# TECHNICAL MEMO

Project	362 Jones Road Drury
Subject	Section 92 Request for Information: BUN60440759
From:	Leo Hills
Date	24 November 2025

**Figure 11-1: Locations of Crashes**

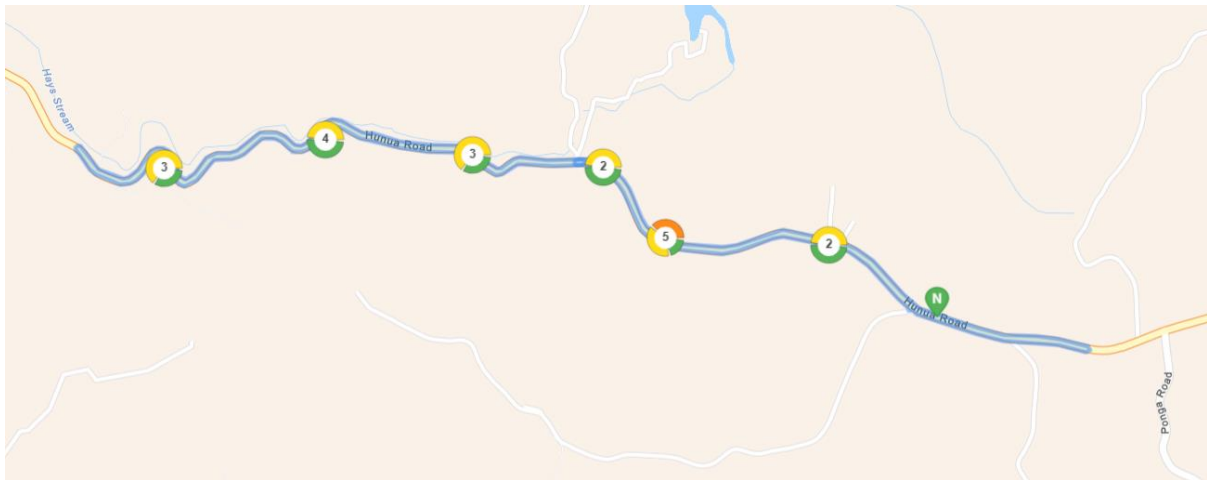
*AT would like the applicant to provide more analysis of the locations of the loss-of-control crashes. We want to see if there are any particular curves or other locations where improvements to that part of the road could be used as mitigation the proposal, rather than asking the applicant to upgrade/widen the whole road.*

- A more detailed assessment has been assessment of the surrounding area's road safety record has been undertaken using the NZTA's CAS database for only loss of control crashes in the gorge itself (from the Quarry entrance to the site entrance). Crash records for the five year period 2020 - 2024 including all available records for 2025. The results show:

- A total of 20 loss of control crashes were recorded in the above study area, comprising of 8 non-injury crashes, 10 minor-injury crashes, and 2 serious-injury crashes.

- It should be noted that 8 of these loss of control crashes (40%) occurred at night when the fill site will not be operating.
  - Figure 11-1 below shows the approximate location of the above crashes within the study area. In general, the loss of control crashes are quite spread out along the corridor.

- Areas A and C/D in Figure 3-1 previous had three loss of control crashes each, while Area B did not have any.
